V2500-A1/A5 SERIES PROPULSION SYSTEMS SERVICE BULLETIN

V2500-ENG-72-0504

ENGINE – MAIN GEARBOX ASSEMBLY – TO ANNOUNCE A NEW DEOILER CASING1. Planning InformationA. Effectivity

Rework of the Deoiler Casing
Figure 1

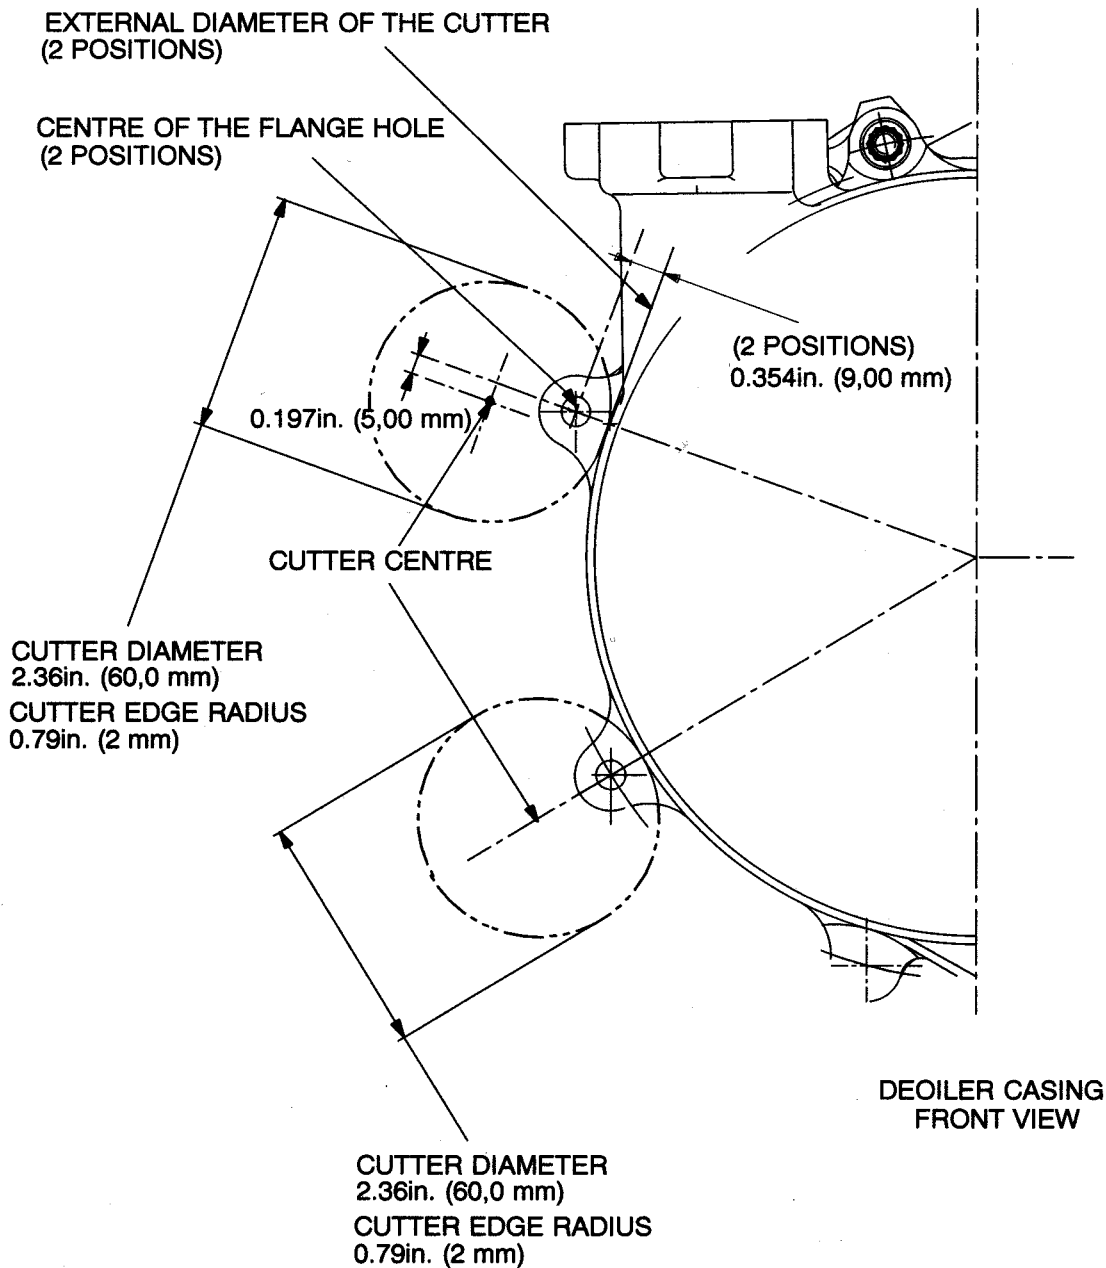
There is interference between the new bracket, P/N 6A8166 (72-60-10, 01-457) and the material around the flange of the deoiler housing.

(1) The new deoiler housing does not interfere with the new bracket.

(2) The old deoiler housing can be reworked to the new standard.

- (3) Use the center line of the air port as dimensional reference.
- (4) Machine the deoiler casing around the two flange holes at positions 8 and 10 o'clock, front view of the deoiler casing, looking afterwards. Refer to the scheme of Fig.1. Use a cutting tool with a diameter of 2.36in. (60,0 mm) and an edge radius of 0.08in. (2 mm). It is not required to use a specific tool. If the cutting tool touches the rough surface of the deoiler casing, the thickness of the casing will be equal or more than 0.35in. (9 mm). Make sure you do not decrease the thickness of the flange. Surface finish must be 1,6 micron.

- (5) A fluorescent penetrant inspection is not required. If you think that the inspection is required, do a local fluorescent inspection in accordance with Standard Practices Manual 70-23-05-230-501, use Comat 06-063 (medium post-emulsified). Cracks are not allowed.

- (6) Apply chromate conversion coating in accordance with Standard Practices Manual 70-38-02-300-503 to machined areas.
- (7) Cross out the old part number 4B7262 and mark the new and one 4B7361. Refer to Standard Practices Manual 70-09-400-501, vibration peening.
